**DESIGN REVIEW**

***LAVITA APARTMENT***

**4055 8th Ave NE**

**DPD Project # 3012892**

**Window location**

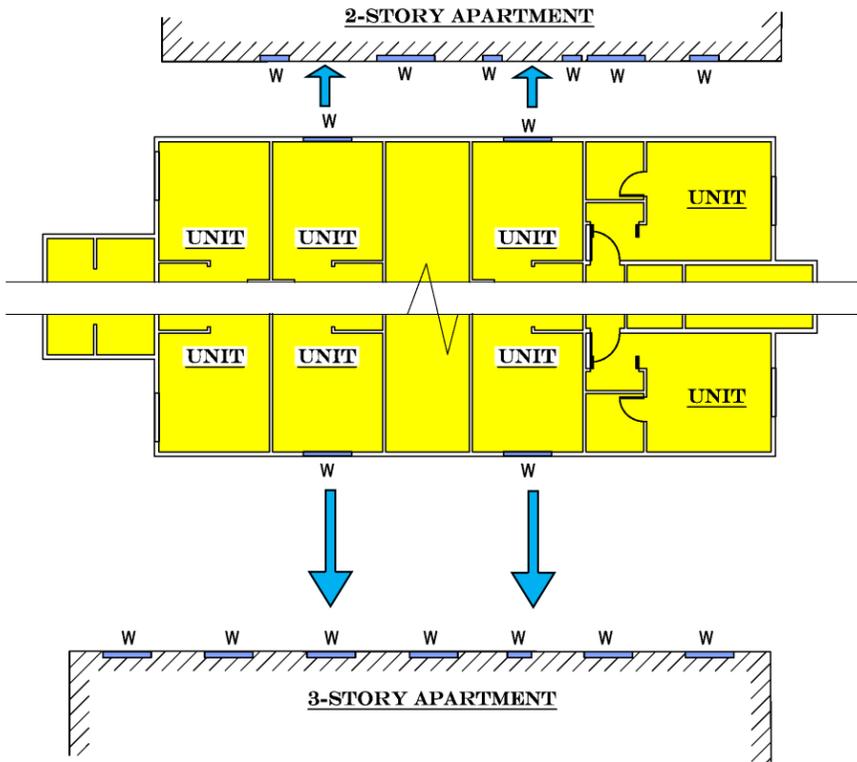
The relationship of the proposed structure to the neighbors as rendered in options B and C seems adequate to the Board. The architect should be sensitive to the privacy of the tenants and the neighbors by ensuring that windows are not aligned.

The modified design is combination of option B & C at the EDG phase. The site is located between two multi-family properties, to achieve the privacy, the number of dwelling units with windows facing adjacent properties is minimized, though one set of windows is still facing southern neighbor windows due to excessive windows on the adjacent new apartment. Yet, the balcony provide certain view blocking from neighbors.

**Open Space and Transition**

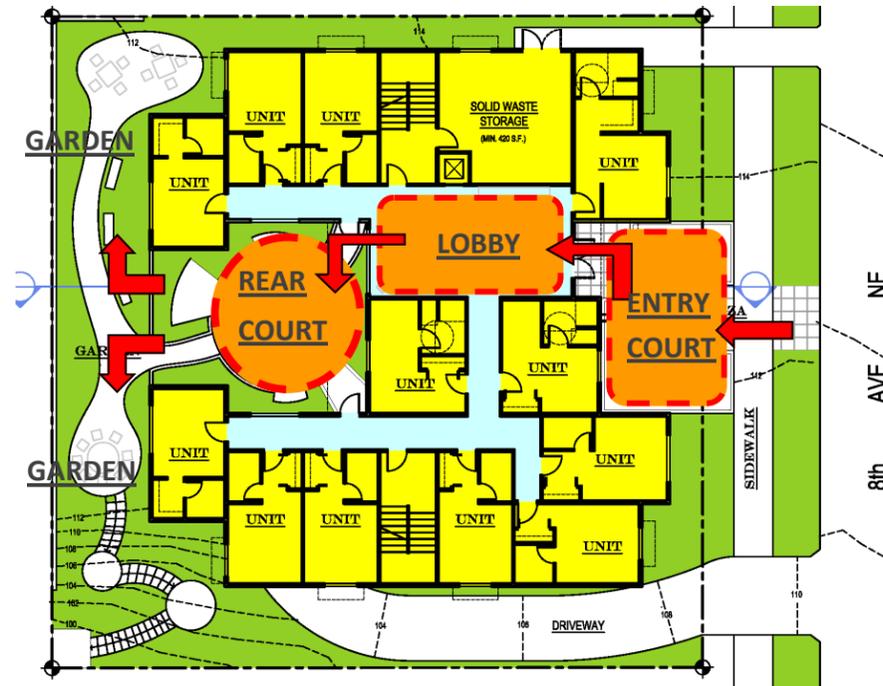
Considerable deliberation occurred on the configuration of the two courtyards. The architect should develop a hybrid of scheme B and C. The Board finds the circulation and relationship of the courtyards to the lobby in scheme B appealing, the rear courtyard should be the major open space linked by lobby to the minor open space of the entry court. Both should have amenities for the tenants (seating, garden, etc) as they will be used in different manners during the day and seasons. Option C had qualities that the Board also liked. The entry court, which would be ideally smaller than this option, should be open to the sky similar to Option C rather than partially enclosed as Option B. The plan configuration of Option C might work if one of the units between the lobby and the rear deck were shifted allowing direct circulation from entry court to lobby to rear court. Ground level units facing the rear courtyard should have a defined area separate from the courtyard which is for their private use.

The modified scheme is adopting the advantages of EDG design option B and C. the entry court size is reduced and still provide benches and planters as amenities, while rear court is spacious and private for tenant's use with connection to rear garden. The rear garden is created by partially fill to be level with rear court, and provides better privacy from western properties.

**Building Section**

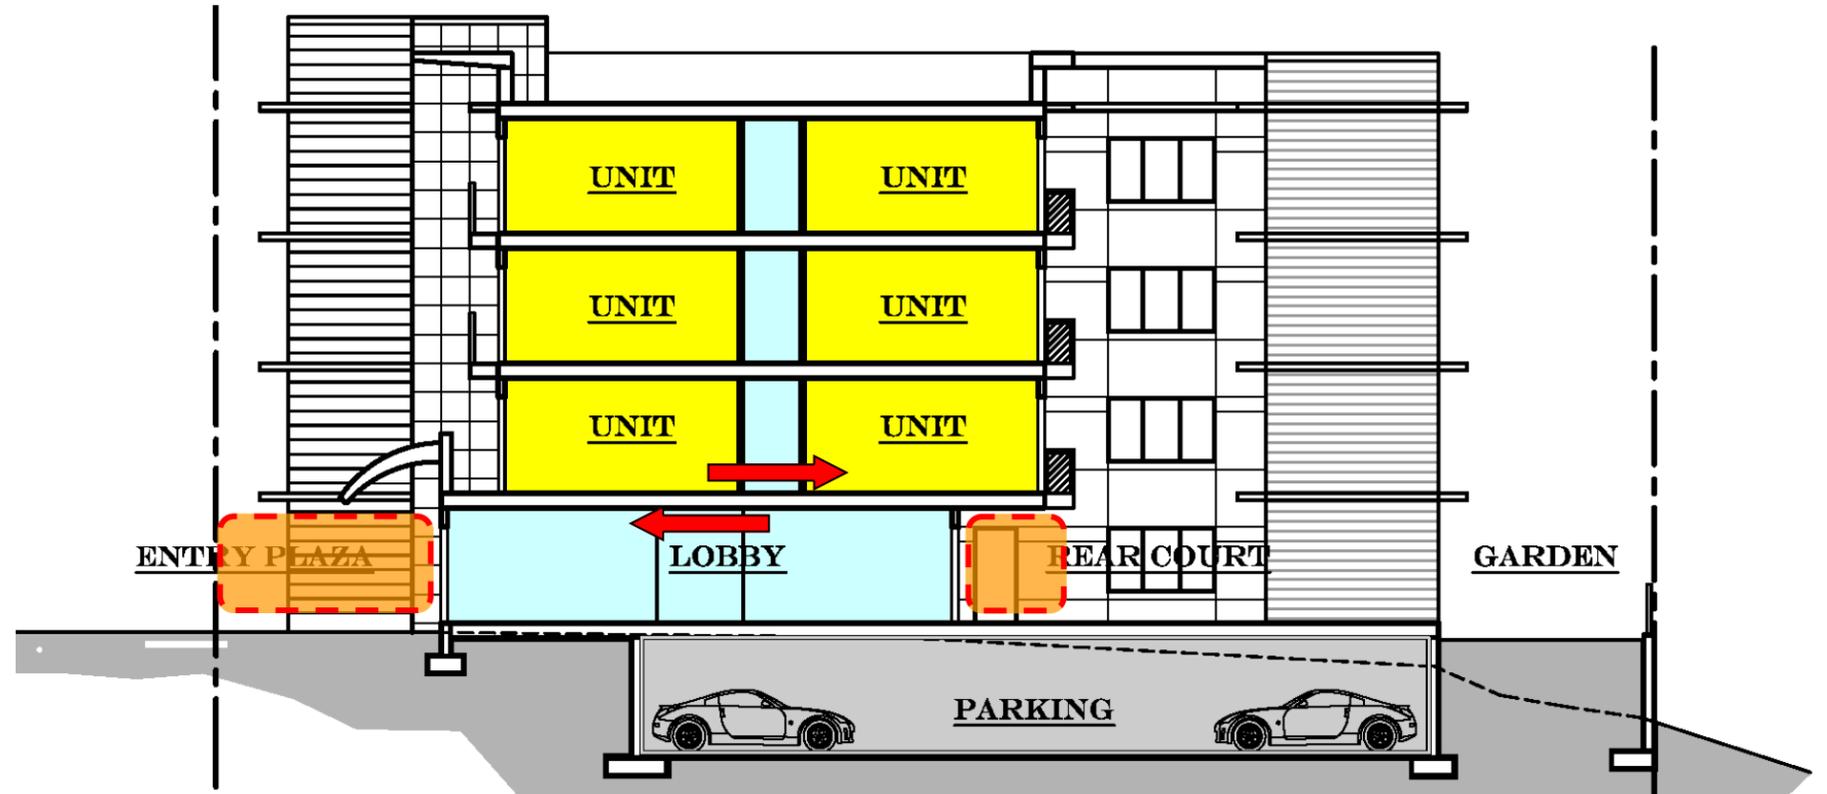
The architect's ability to achieve a strong and consistent concept will be among the Board's significant considerations when it reviews the project at the Recommendation meeting.

Providing great amenity areas for more and better uses by tenants is the main target of the project. In addition to the strategies responded to previous design guidance, the central portion of ground floor is offset with upper floors to define entry court, and meanwhile creates shade area for rear court.

**LANDSCAPE DESIGN PLAN**  
LOTUS LANDSCAPE DESIGN

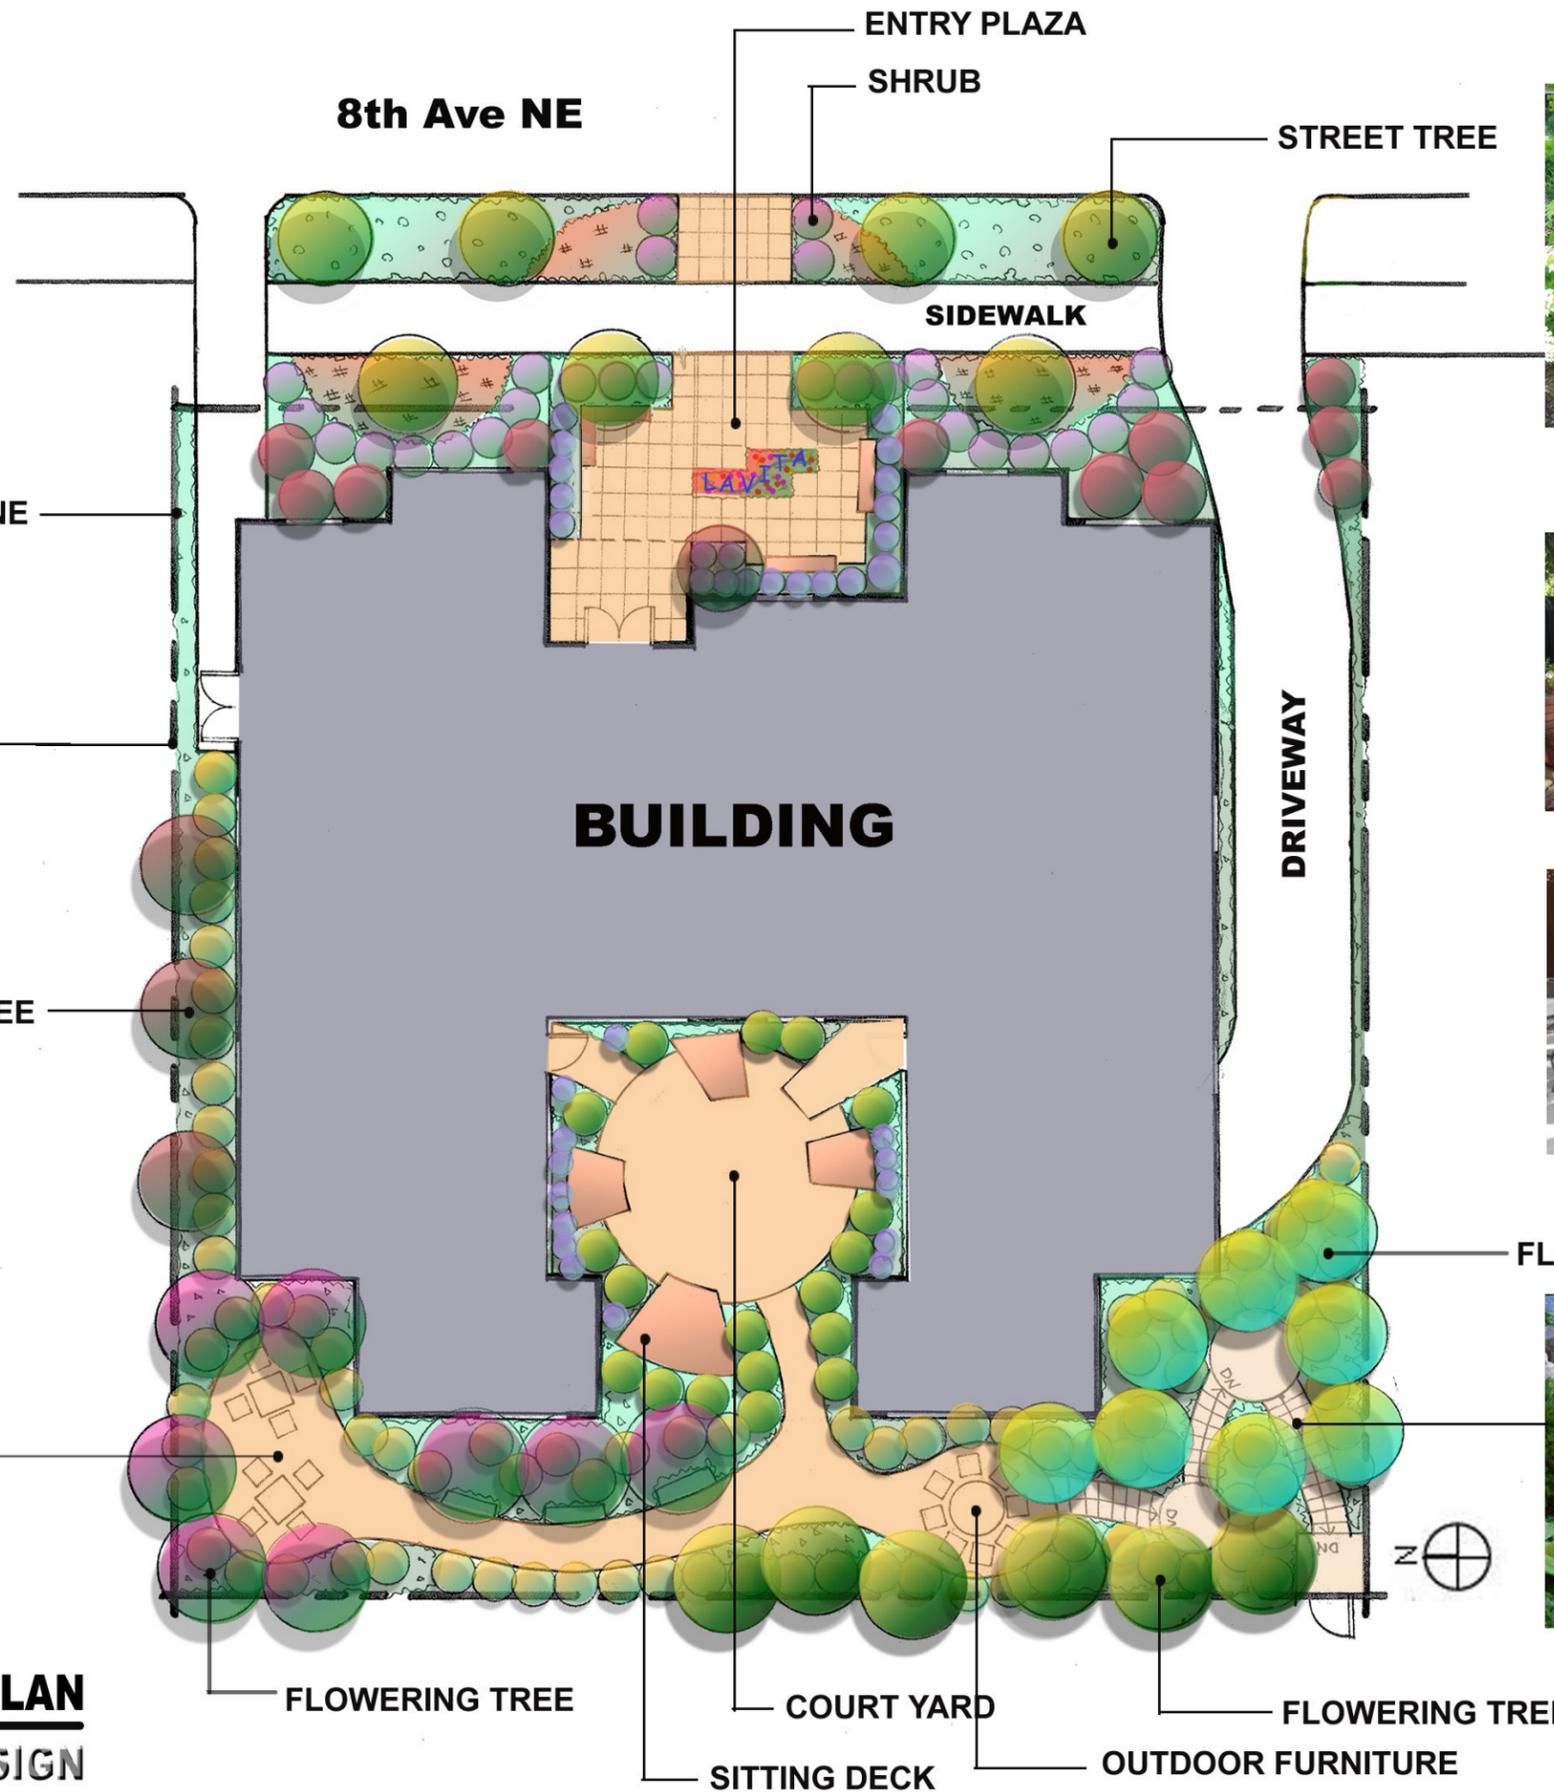
The two courtyards should be well landscaped and accommodate a variety of tenant uses. The entry court ought to be gracious and welcoming with seating and a strong visible connection to the street.

- 1) Entry court: Smaller and open with benches and planters for heavier tenants' traffic.
- 2) Rear court: Circular paving design and open with more benches for tenants' interactions.
- 3) Garden: Abundant plants for better privacy from adjacent properties.

**LAVITA LIGHTING PLAN & IMAGES**

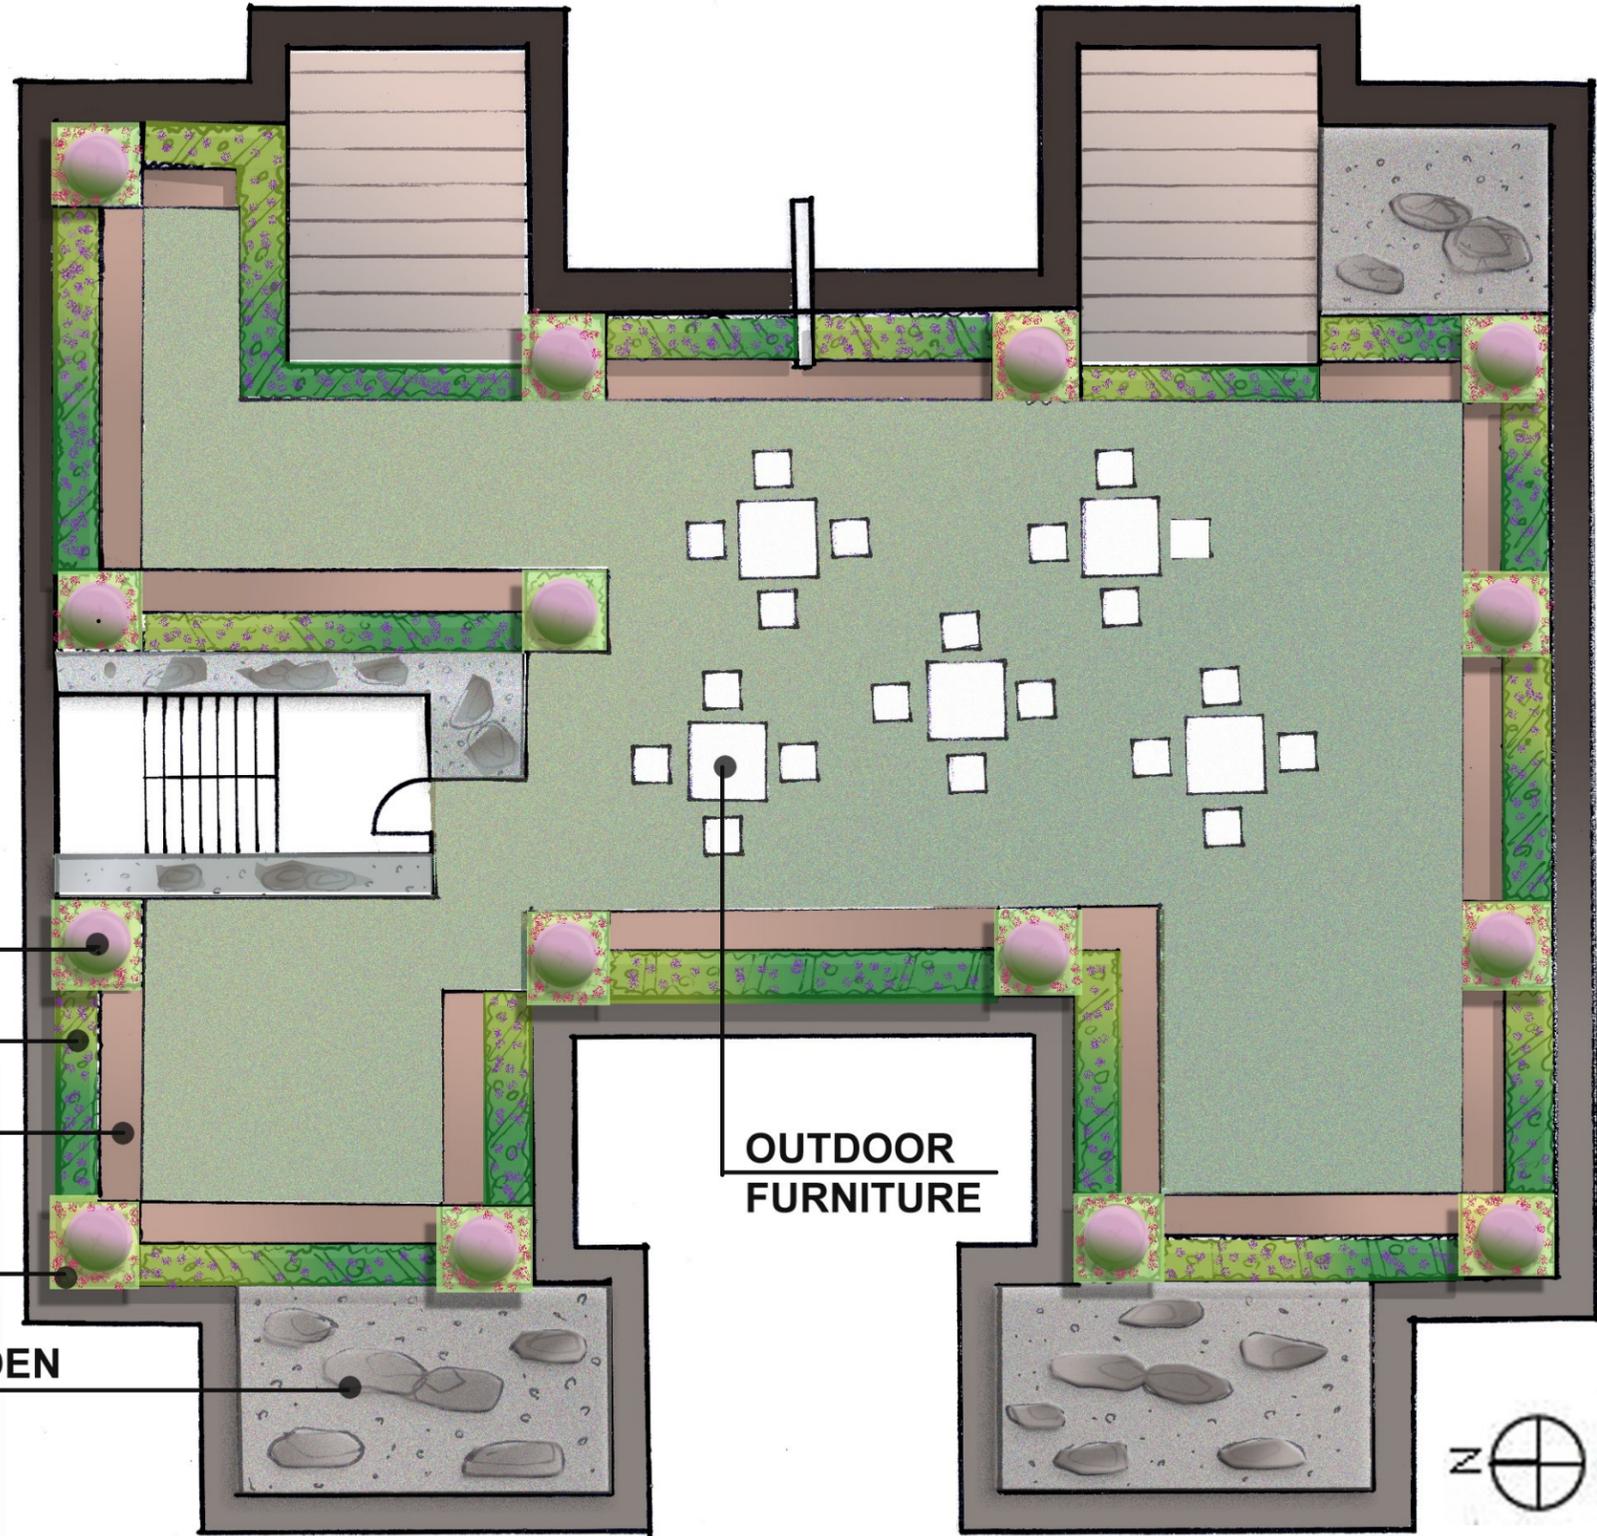
A lighting plan should be submitted at the time of the MUP and presented at the Recommendation meeting.

The size of entry court is reduced with planters on front for better security while still remains open without dead corners. The large lobby providing amenity area will also help watch activities at front and rear courts by tenants. Optional entry gate and fence (open design; not shown on plans) will be for advanced security. See landscaping plan for outdoor lighting.
